AGENDA
ARCHITECTURAL REVIEW BOARD MEETING
Conference Room 102-103
Thursday, July 9, 2026
5:30 PM

Description: Chesterfield Village Mall, Lot 3B: An Amended Site Development Section Plan, Landscape Plan, Lighting Plan, Architectural Elevations, and Architect's Statement of Design for a 16.82-acre tract of land zoned "PC&R" Planned Commercial and Residential located east of Chesterfield Parkway West and west of Chesterfield Center.

Description: **Hilltown Village Lot 2 (Good Clean Dog):** An Amended Site Development Section Plan, Landscape Plan, Lighting Plan, and Amended Architectural Elevations for part of a 2.56-acre tract of land located at the intersection of Hilltown Village Center and Olive Boulevard.

LIGHT PLAN

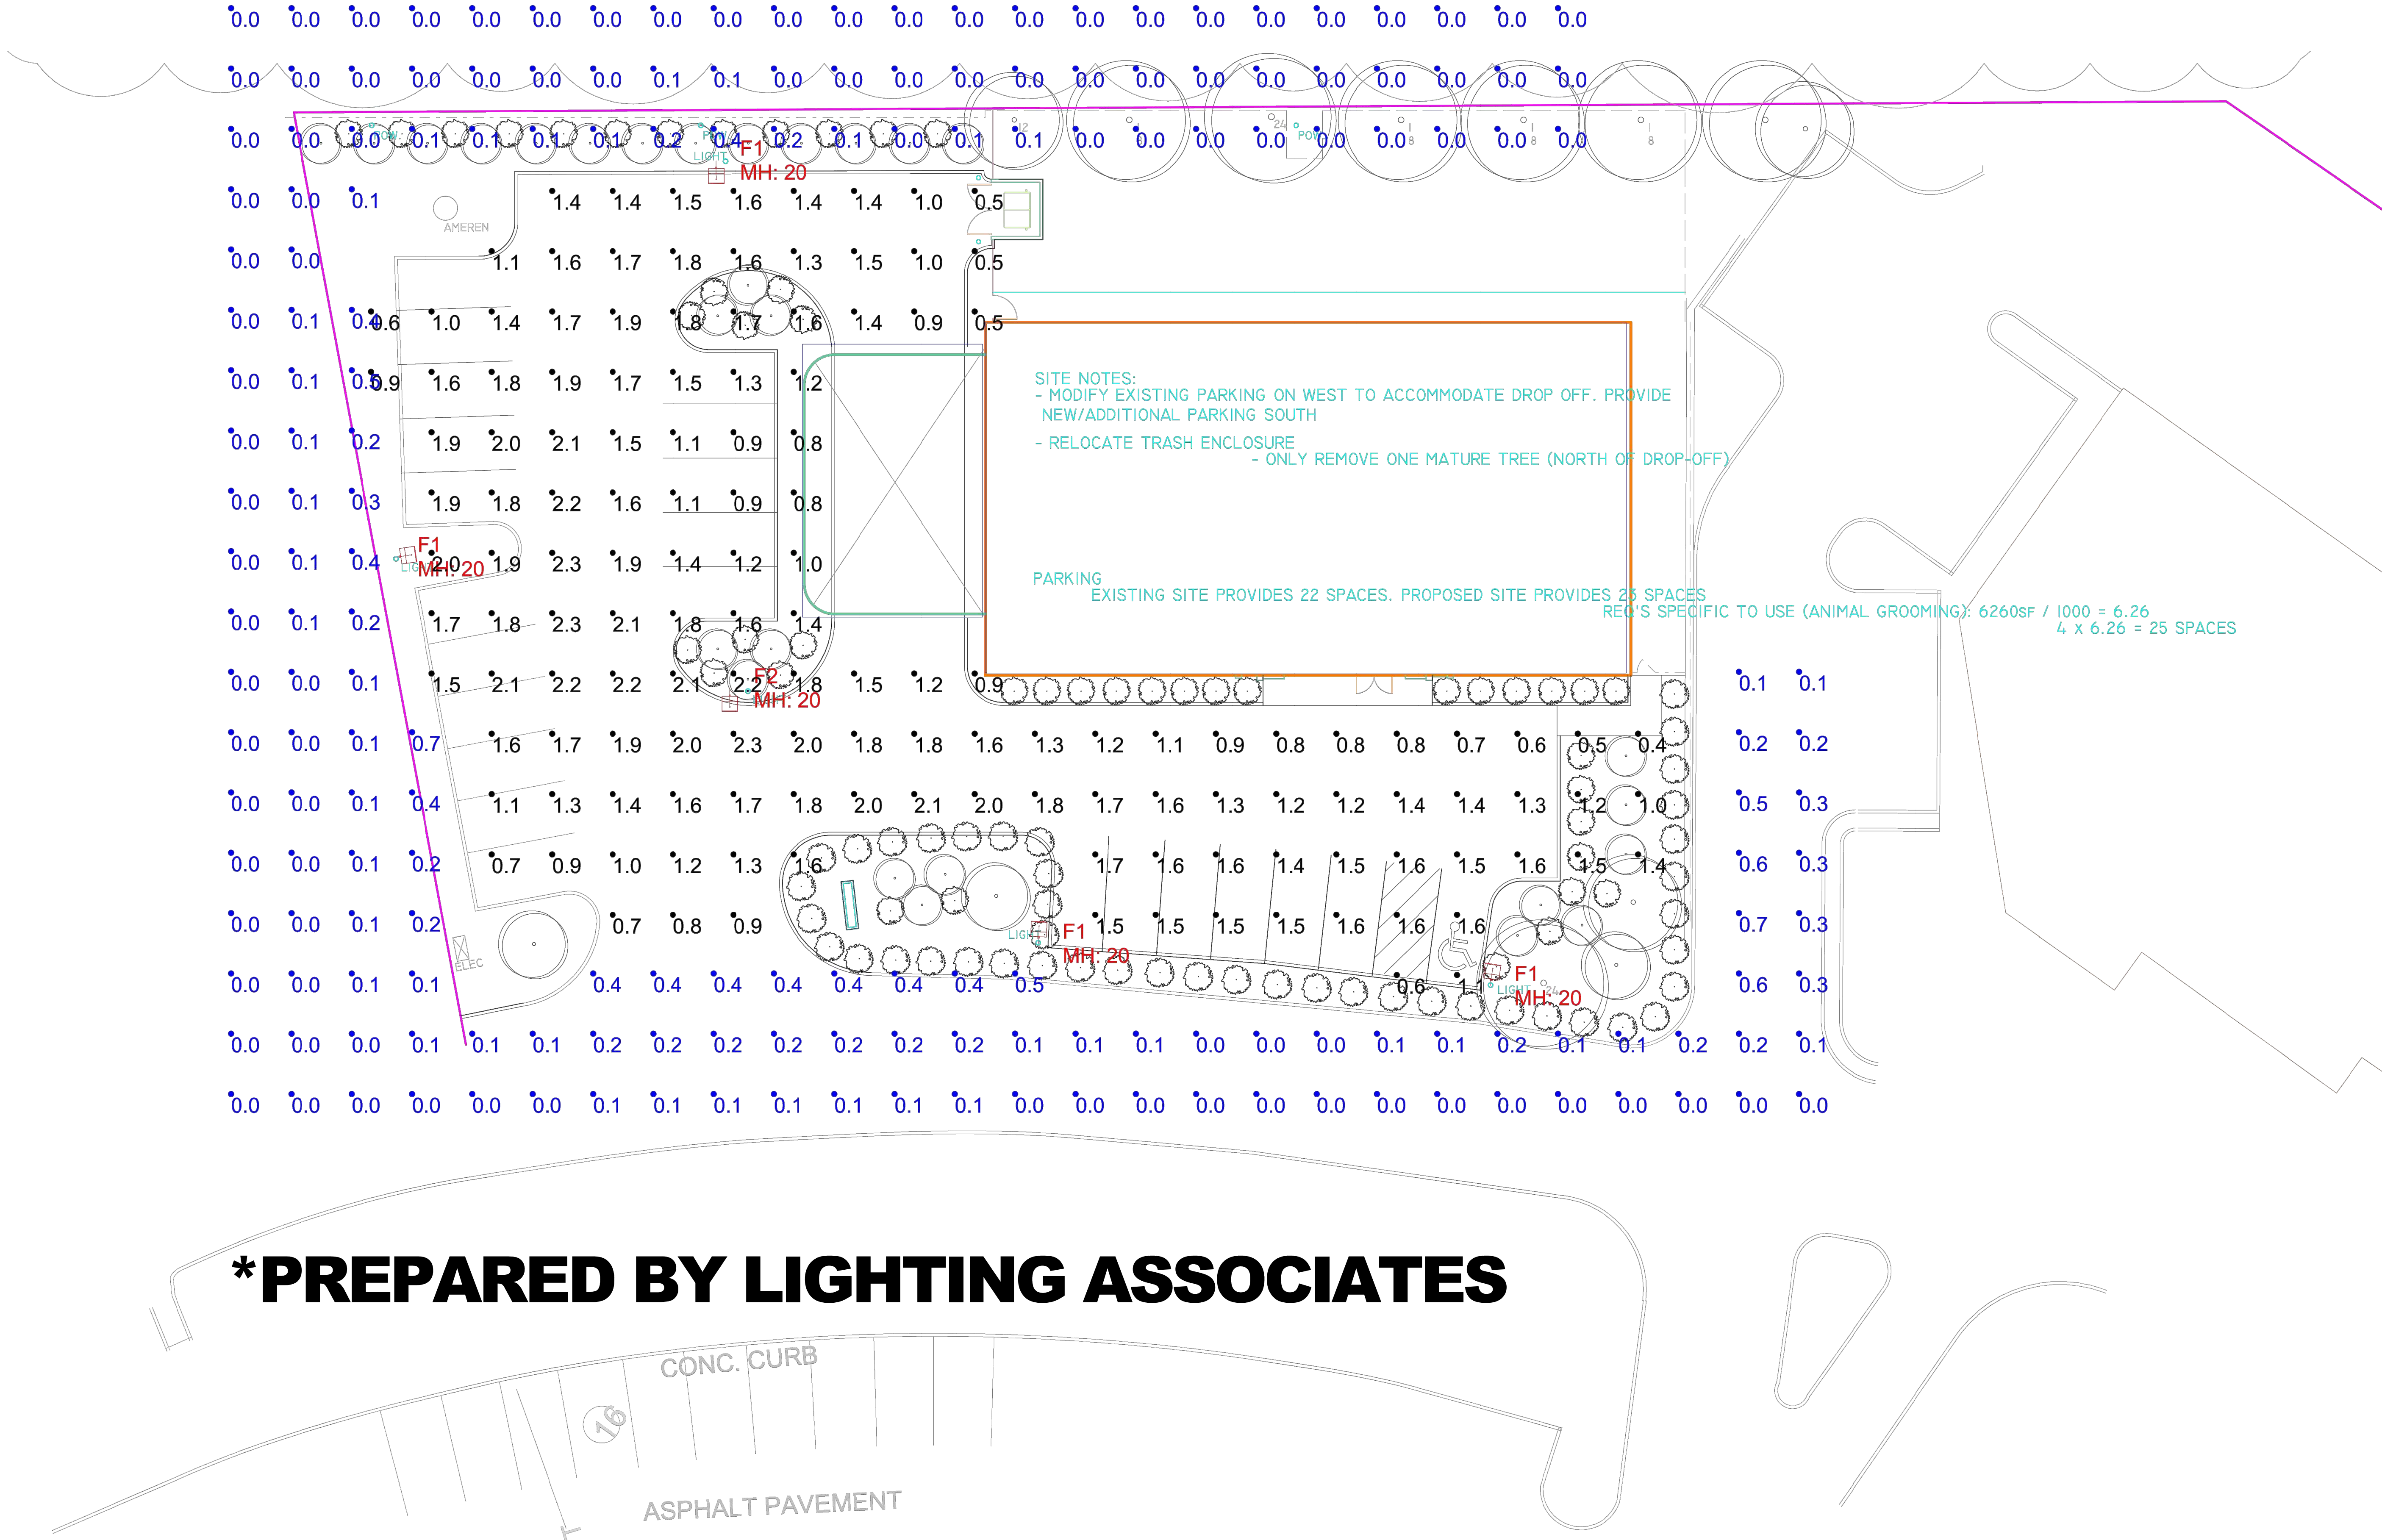
14. The lighting plan depicts a light spill value of 0.7. Revise the lighting plan so that light spill onto adjoining property is eliminated.

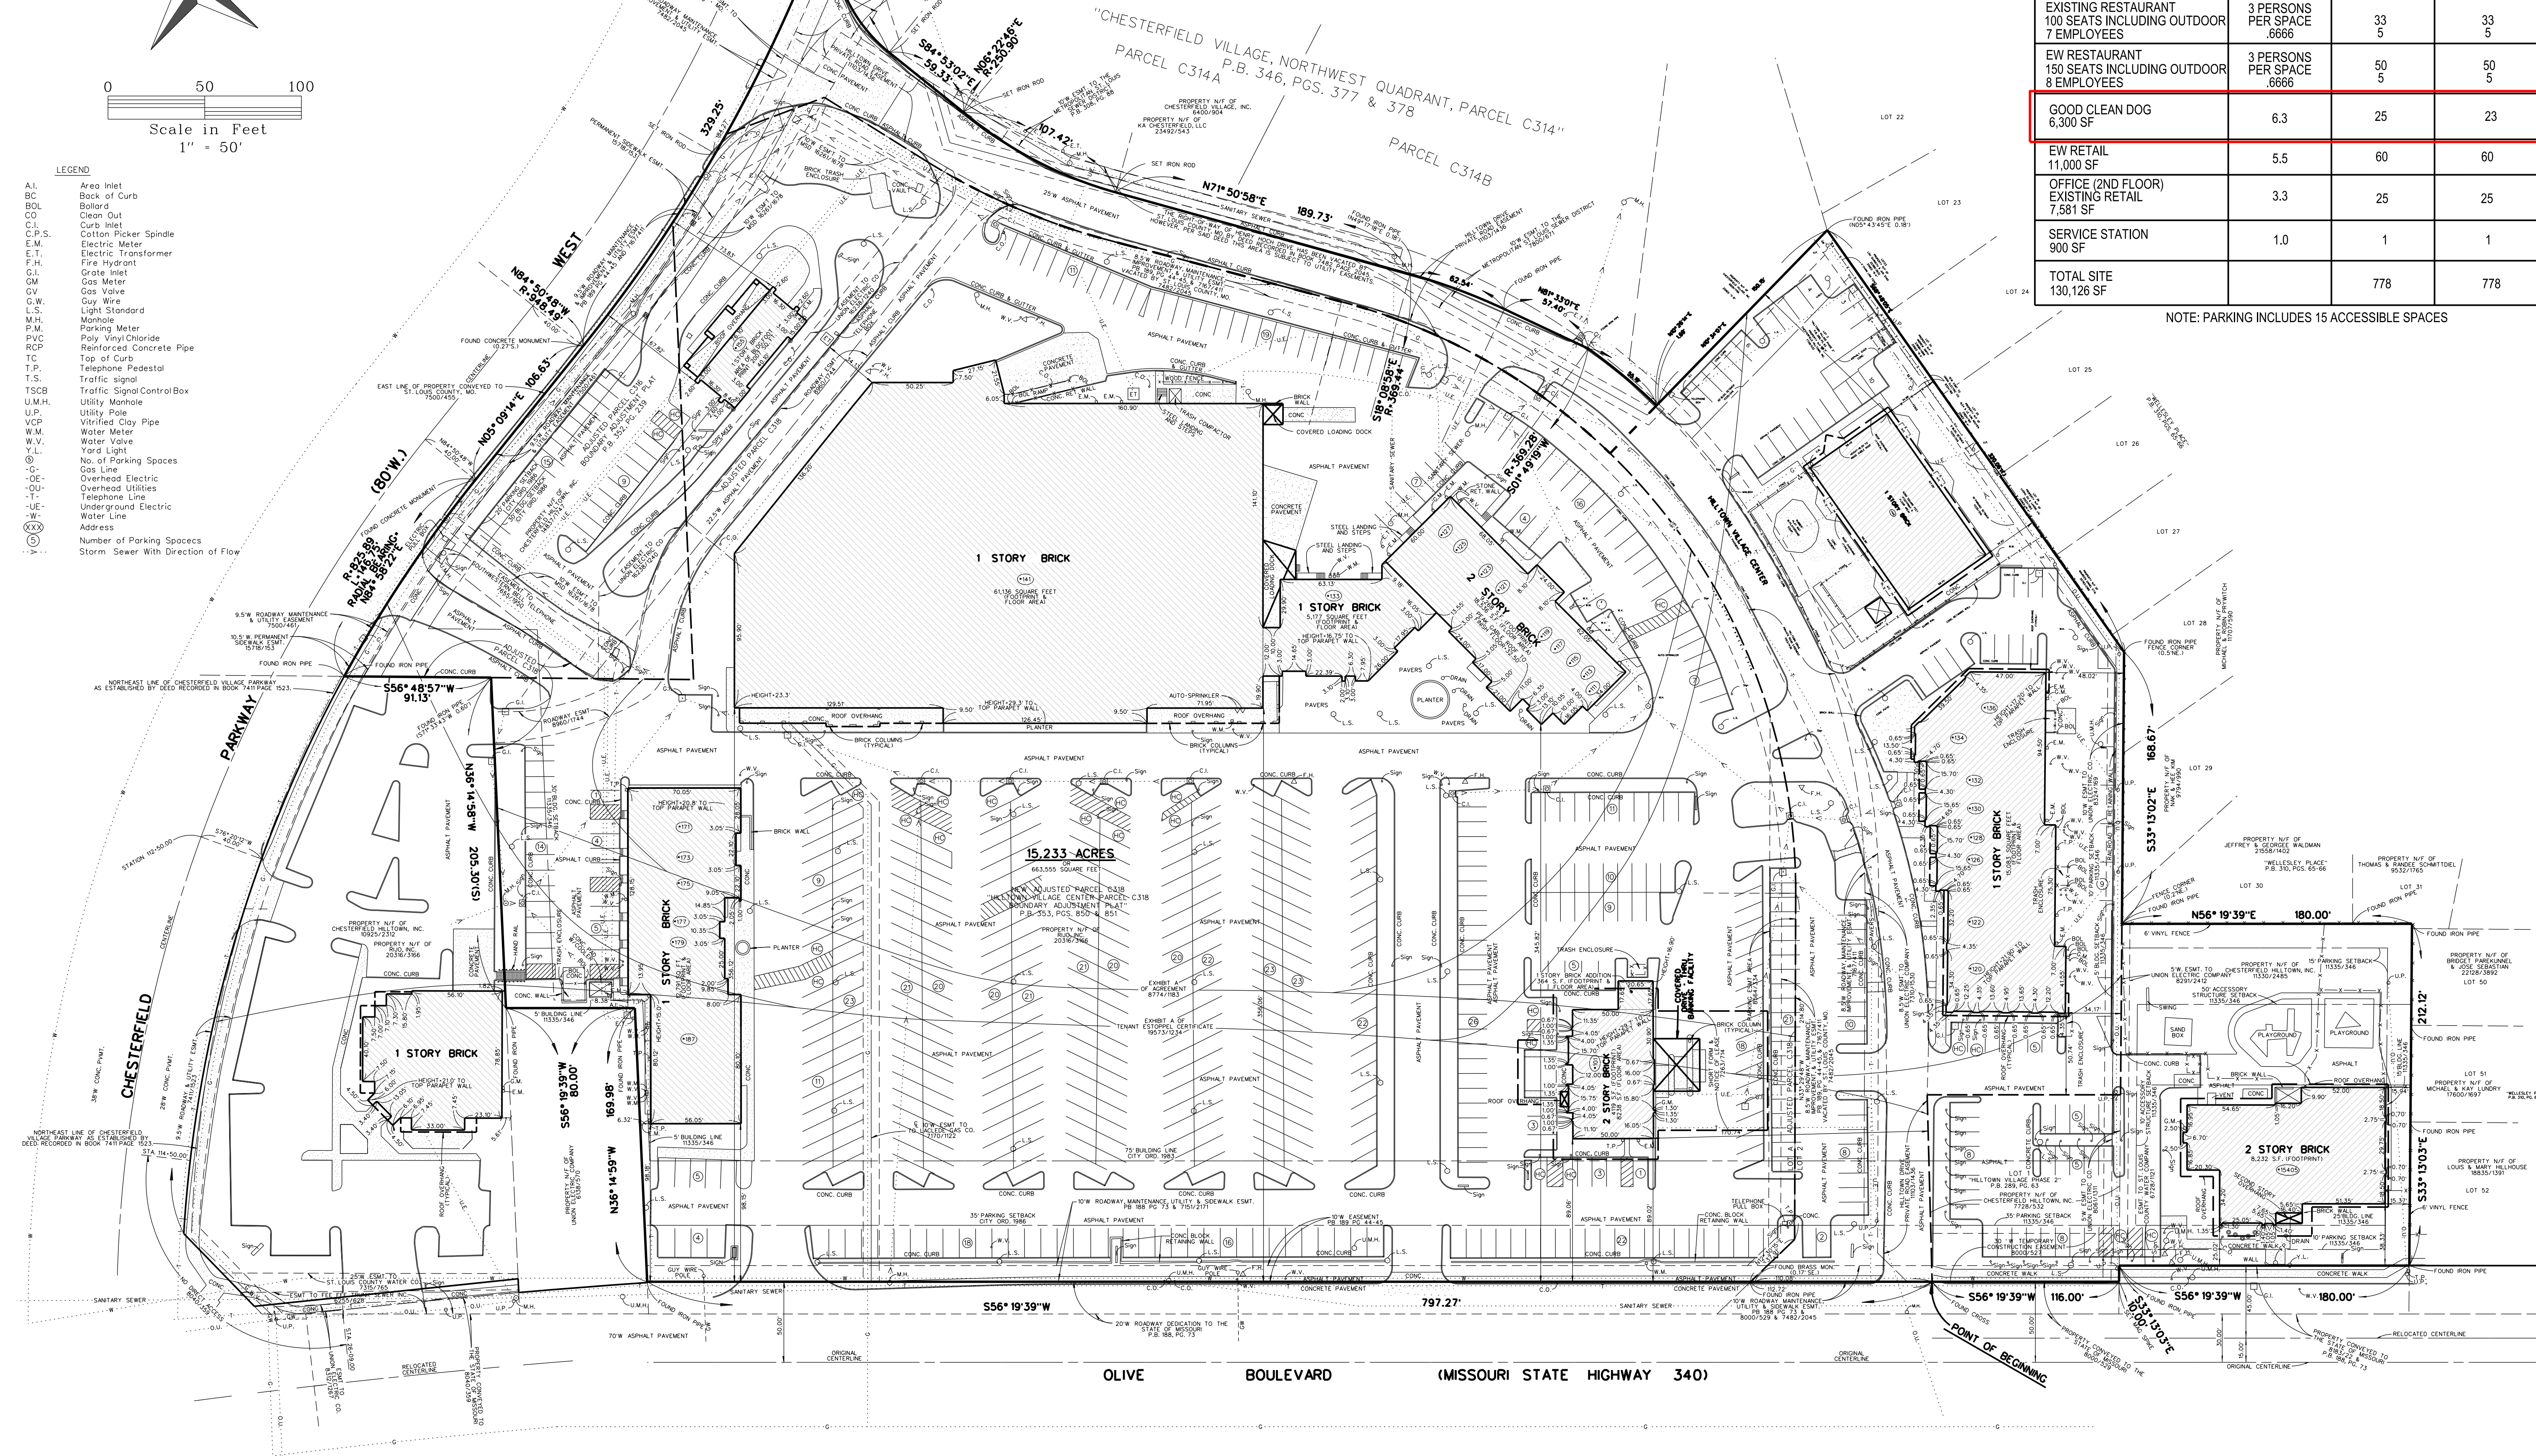
12. Provide the updated parking calculation data for the Hilltown village subdivision overall plan governed by site specific ordinance 1272. See attached figure for previously approved overall parking data. Hilltown Village, Lot 2 2026 ASDSP 6/5/2026

The parking table has been updated see sheet 04
